## **ALABAMA** **DEPARTMENT OF TRANSPORTATION**

### **MEMORANDUM**

DATE: March 7, 2023  
TO: KMT  
FROM: ALDOT  
RE: Utility – Alabama Power Transmission

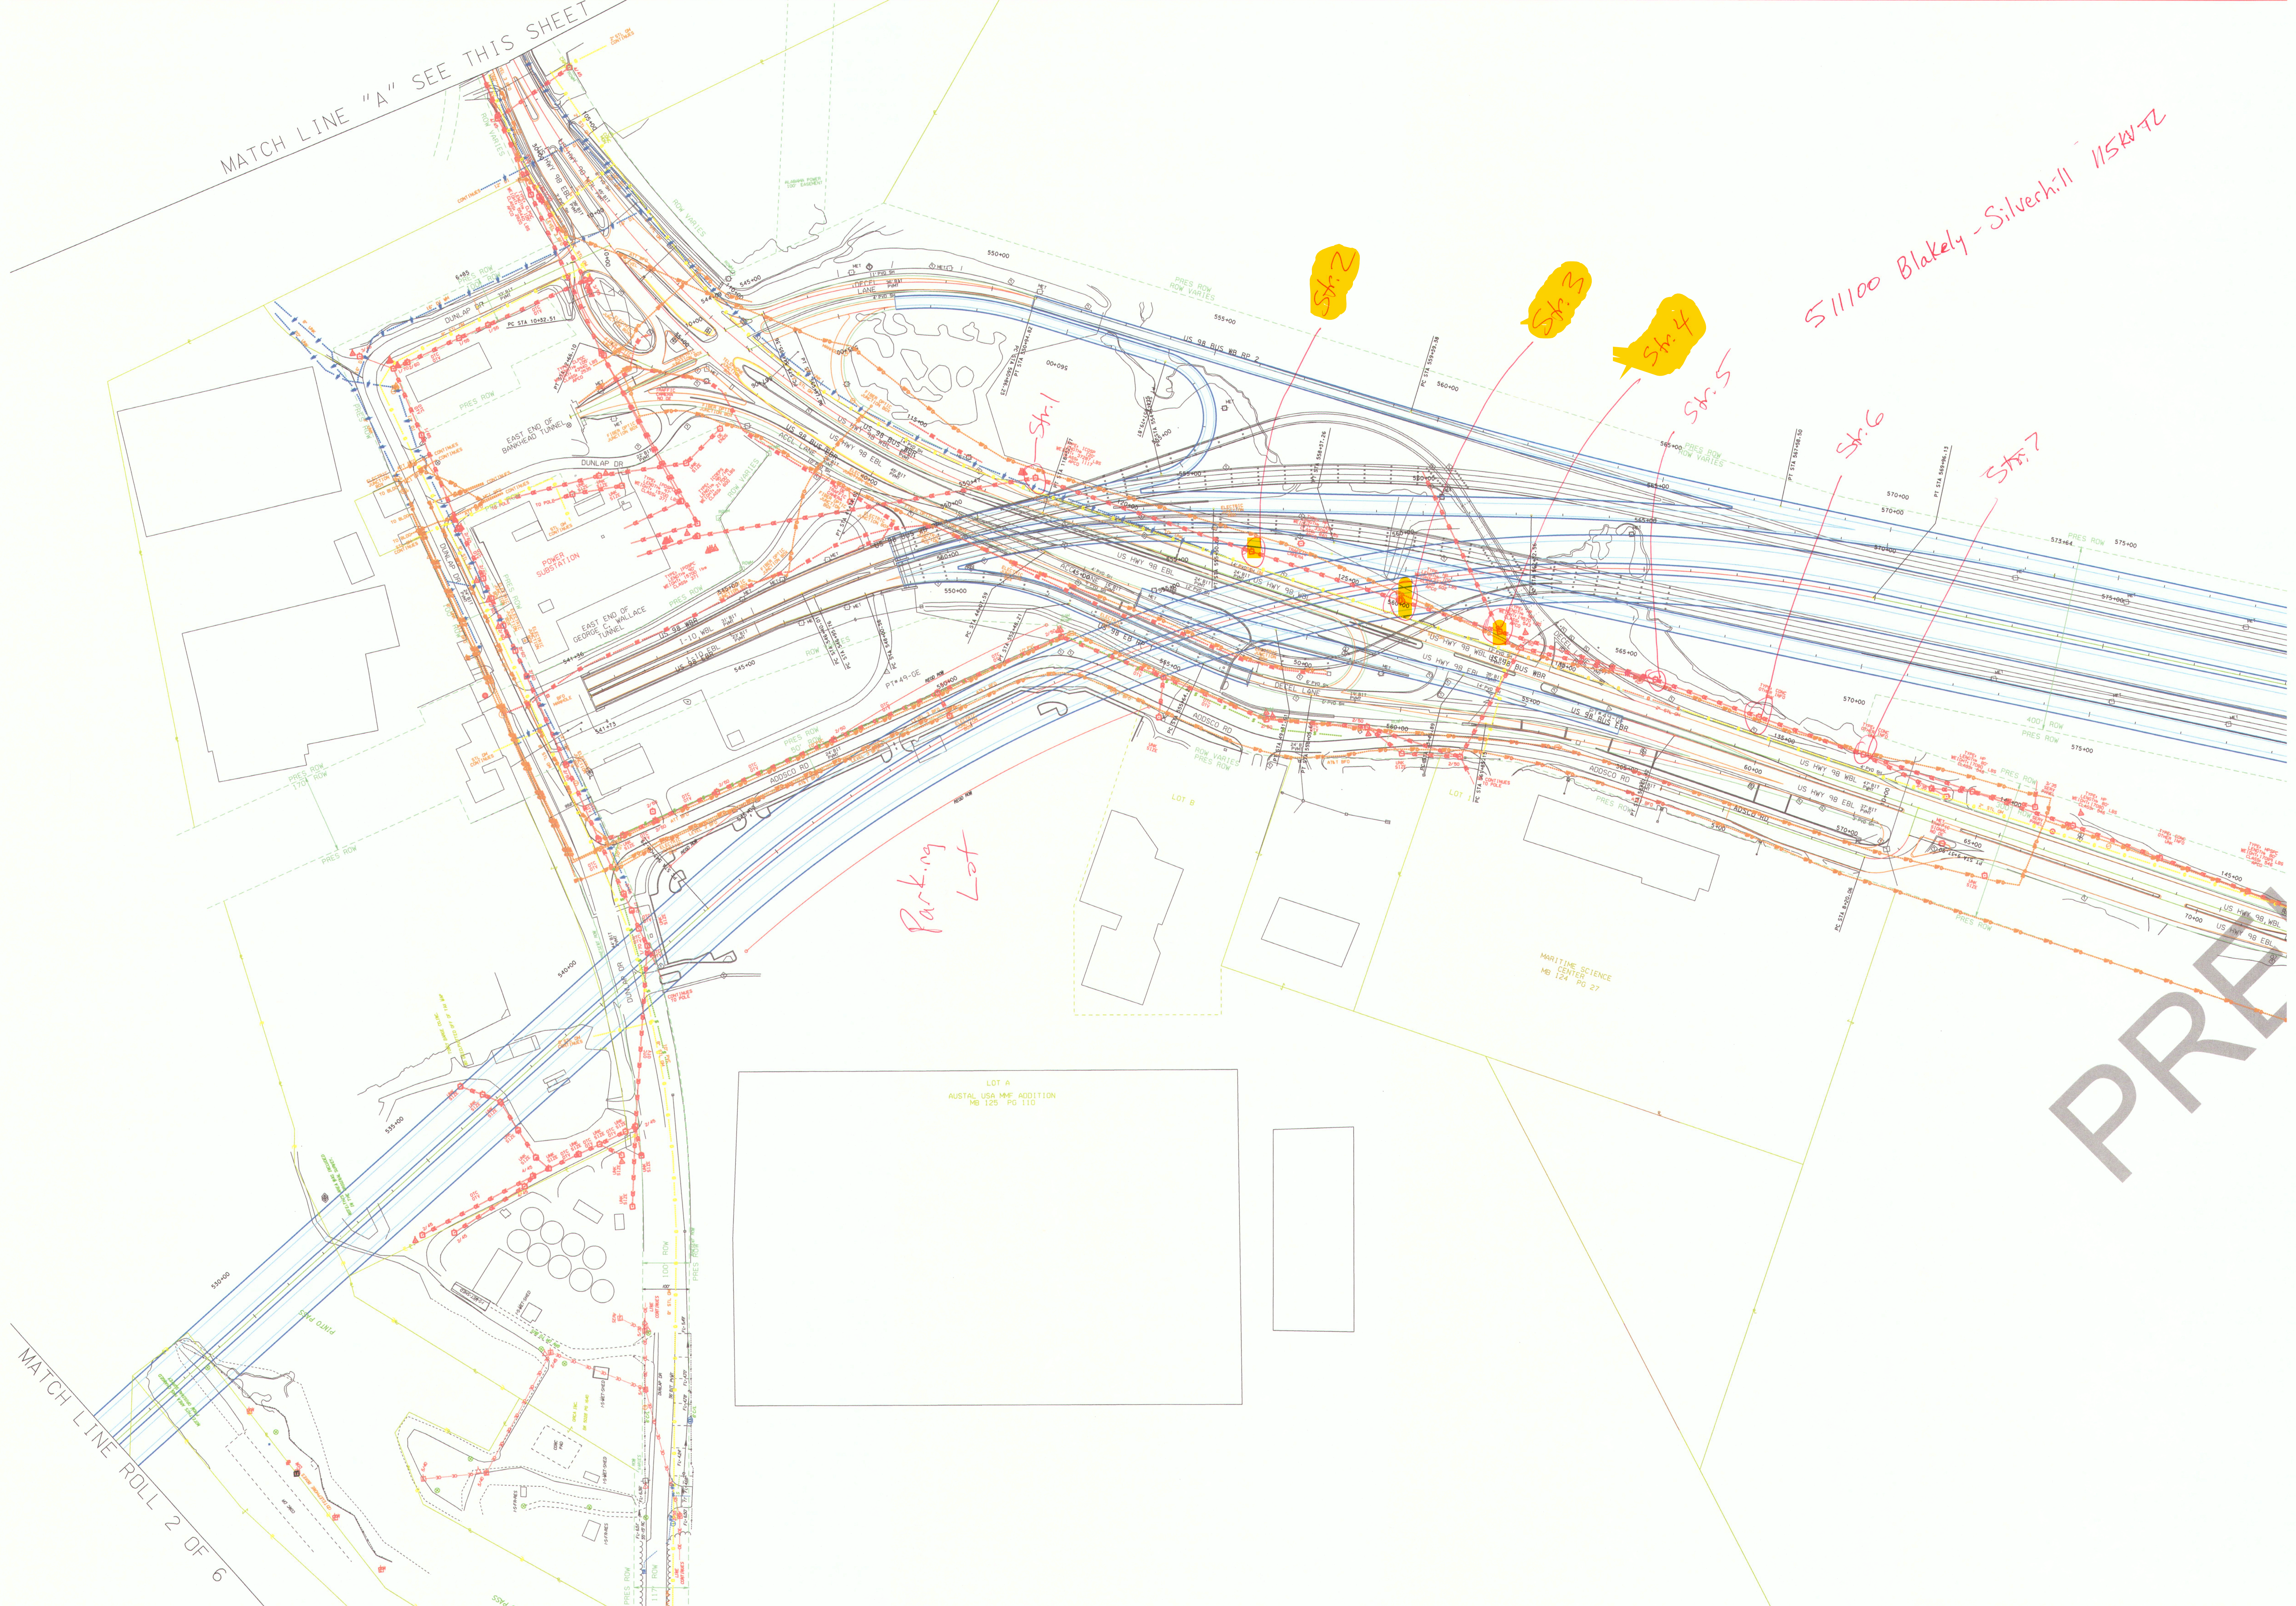
Structure (pole) #3 & #5 will stay in place and be raised to a height of 195' (top of pole), the conductor elevation will be approximately 135' (bottom conductor elevation) (see attached map for structure locations)  
Structure (pole) #4 will be removed
